PARTS & SERVICE NEWS

REF NO.	A960022A
DATE	April 15, 2004

SUBJECT: REPAIR OF BELLCRANK FOR HIGH LIFT BOOM

PURPOSE: To introduce modification procedures to prevent occurrence of interruption between the high lift boom and bell crank on high lift boom specifications on wheel loaders

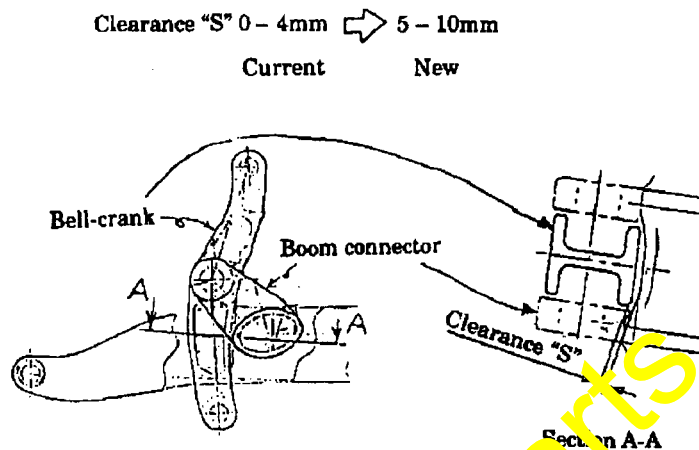
With high lift boom specification, interference may occur between the bell-crank and the boom connector when the bucket is tilted back to its stroke end, causing cracks in the bell crank structure. It is therefore necessary to execute a modification to prevent occurrence of this trouble following the procedures outlined in this **Parts & Service News**.

3-2. Vehicles manufactured from now on

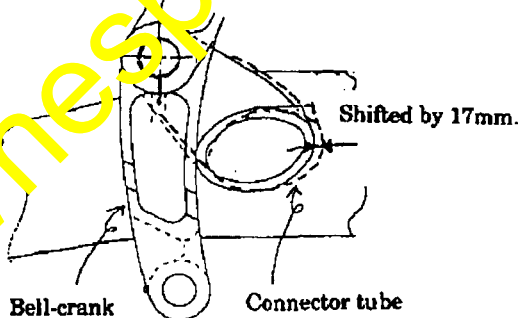
To prevent occurrences of interference between the bell-crank and boom connector, the location of the connector tube is being shifted toward the rear of the vehicle by 17mm.

[Note]: If clearance "S" between the boom connector and the bell-crank remains 5mm or more when the bucket is tilted back to its stroke end, this modification is not necessary.

4. Modification procedures

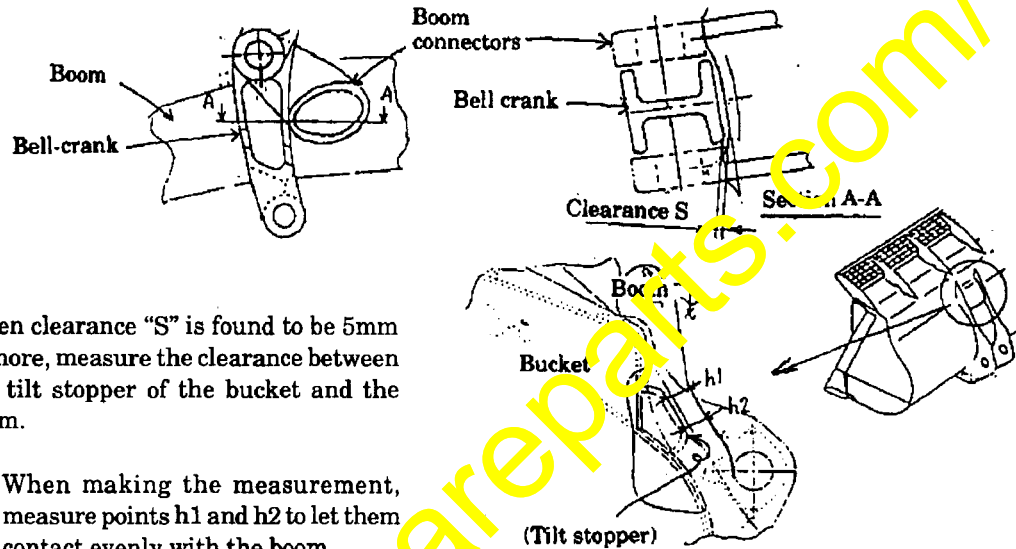
- 4-1. Land the bucket, tilt back the bucket as shown at right before adjusting the bucket control lever so that clearance "S" between the boom connector and the bell-crank becomes 5mm or more.

- 4-2. When clearance "S" is found to be 5mm or more, measure the clearance between the tilt stopper of the bucket and the boom.

★ When making the measurement, measure points h1 and h2 to let them contact evenly with the boom.

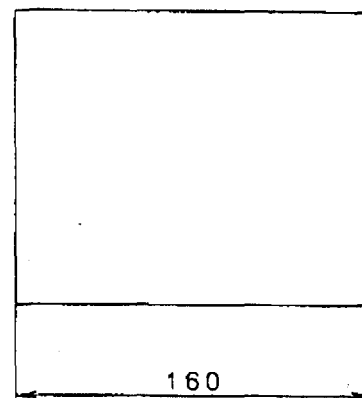
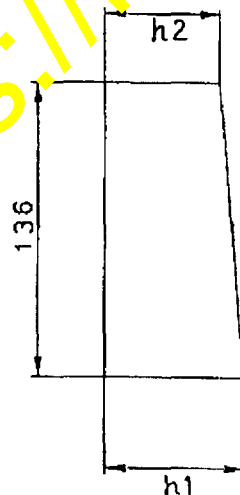
- 4-3. Make a plate according to the following drawing, observing the measurement values of points h1 and h2.

Material: SS400P

Q'ty: 2 pcs/vehicle

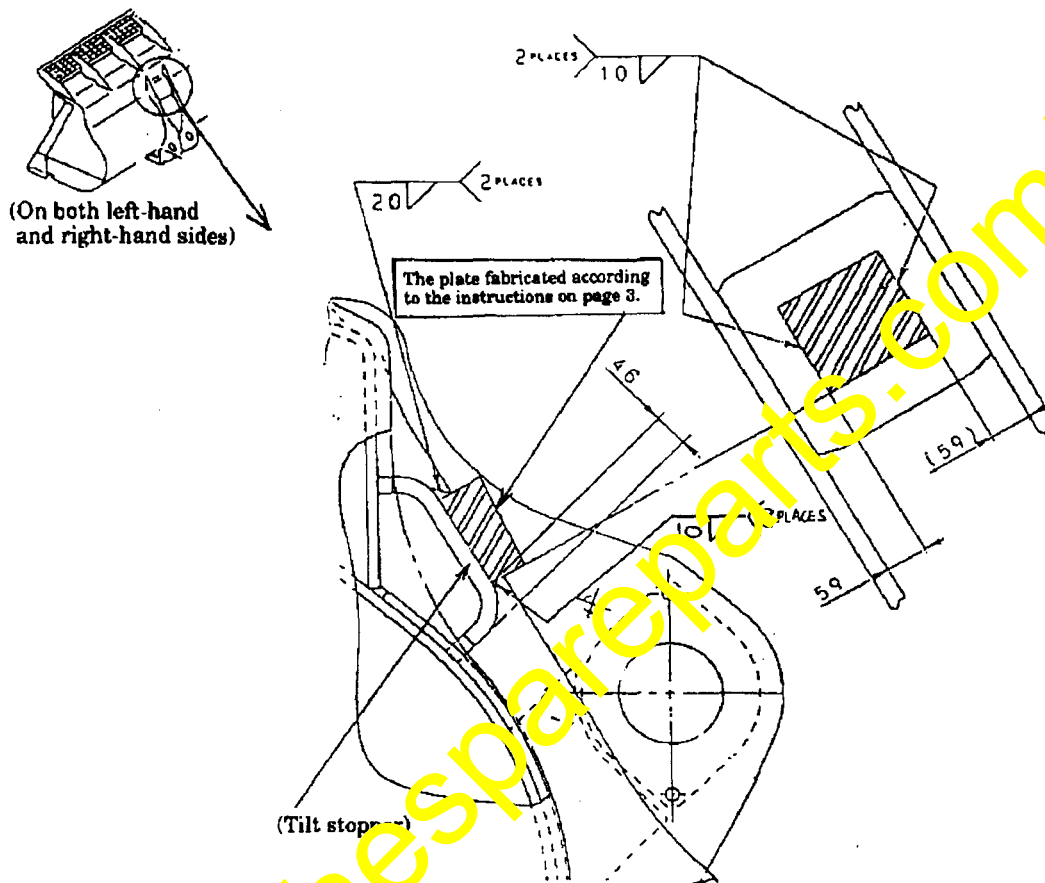
- 4-4. Weld the plate constructed according to the aforementioned instructions to the designated position following the instruction given below.

<Note> Perform tack welding to check if the clearance "S" between the boom connector and the bell-crank is 5mm or more before executing final welding.
